Date: Aug 11, 2020
Applicability: XEM – XPULSE – XDS1 – XBOLT II
Issued By: Jack Rader

BACKGROUND

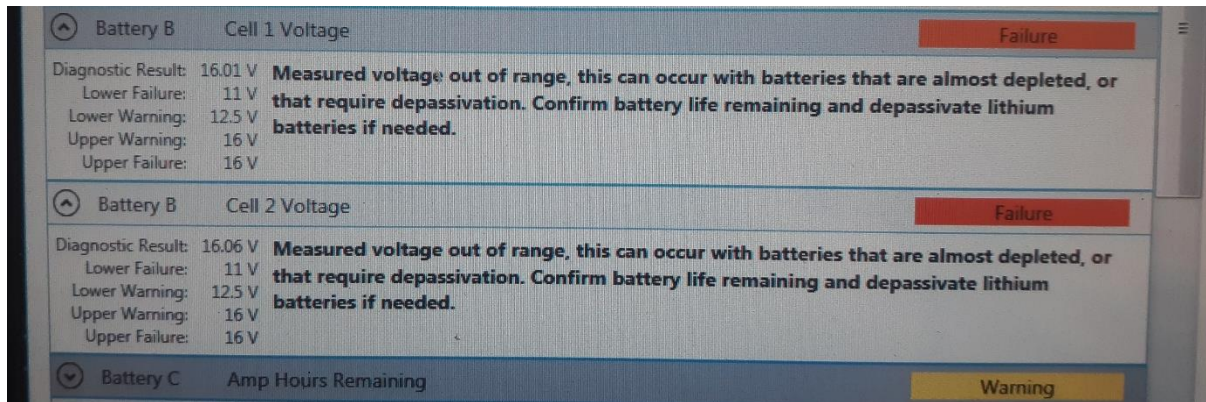
When XDirect conducts the diagnostic testing there are preset ranges for every value that can be read from each probe. For batteries, the cell voltages have had a passing range between 11V and 16V. Historically alkaline cells can see a higher cell voltage than 16V when new. This caused some bank tests to be flagged as failures. An example of this can be seen on the image below.

These failures are a false positive. Though the software is working correctly with the ranges it is given the probes in the example would be good to run down hole.

- The range given for a battery will no longer be a one size fits all. Instead each battery type will have its own specific range. XDirect can distinguish each cell type based on flags set when it is assembled. This update is planned for release the week of August 19th 2020 and can be installed as a patch to any V4 installations of XDirect.
- Alkaline voltage criteria will be changed from 11V – 16V to 11V – 16.6V for passing. The 16.6V was selected because values of up to 16.6V have been recorded on new alkaline cells at the manufacturer's facility.

Bank tests that show a failed voltage between 16V – 16.6V will be passed by the Extreme Command Center and should not be sent in for failure analysis.
